ENCLOSURE 2

MFN 06-211

Compilation of GE Responses to RAIs Related to NEDE-33173P

Non-Proprietary Version

Figure 2.2-1 Sensitivity of Cold Critical Eigenvalue to EPU Operation

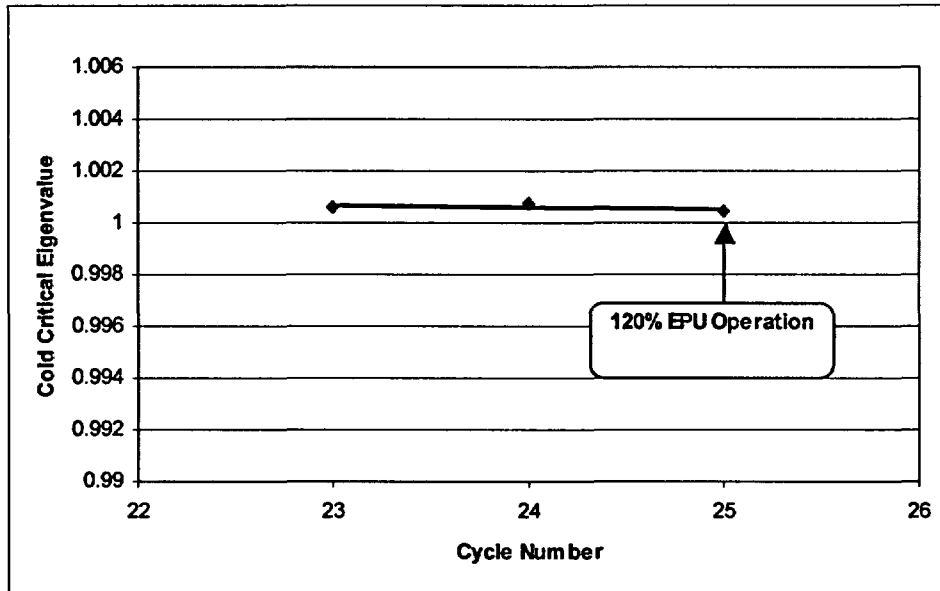
The LTR states that the same SDM Technical Specification value used for non-EPU core designs is adequate for EPU and expanded operating domain conditions. Provide the basis as to why cold SDM is not a strong function of the current operating strategies by comparing cold critical data before and after EPU. Include in the discussion the impact of core designs necessary to achieve EPU and maintain extended cycle lengths (e.g., larger batch fractions, higher bundle enrichments and different core loading patterns).

As a final demonstration of these concepts, the trending of the cold eigenvalues for a BWR/4 through a 120% EPU transition is provided in Figure 2.2-1. The scale of the data is consistent with that given in Figure 2-4 of NEDC-33173P. There is no identifiable aberration with the trend because of EPU.

Figure 4.1d-1 Regional Mode Instability Event and Test Decay Ratios:
ODYSY Results vs. ODYSY Stability Criteria Map

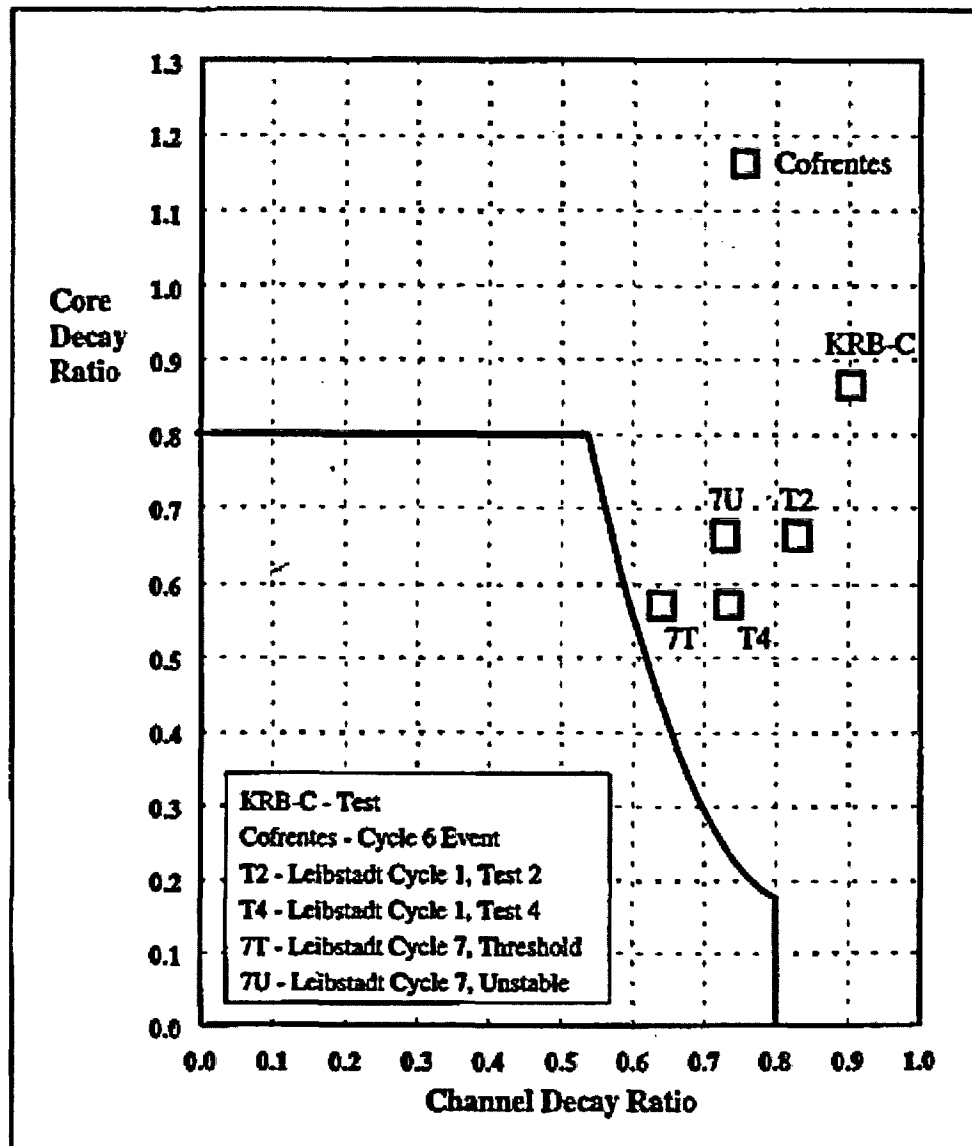
Provide and include the cited instability benchmarking that demonstrates the accuracy of ODYSY and TRACG in the TR. Provide some assessment of the similarities of core thermal-hydraulic conditions between the benchmark plants and the EPU plants.

Reference 4.1(d)-1 also provides ODYSY predicted core and limiting channel decay ratios for regional mode oscillations from tests at Leibstadt and KRB-C and the 1991 Cofrentes instability event. The ODYSY results are compared to the ODYSY stability criteria map in Figure 4.1d-1. Regional mode oscillations are possible when the limiting channel decay ratio exceeds the curved line that begins at 0.56. As can be seen in Figure 4.1d-1, the ODYSY predicted core and limiting channel decay ratios for the tests and instability event exceed the stability criteria. Therefore, the combination of the ODYSY calculated decay ratios and the ODYSY stability criteria map provide a good prediction for regional mode oscillations.
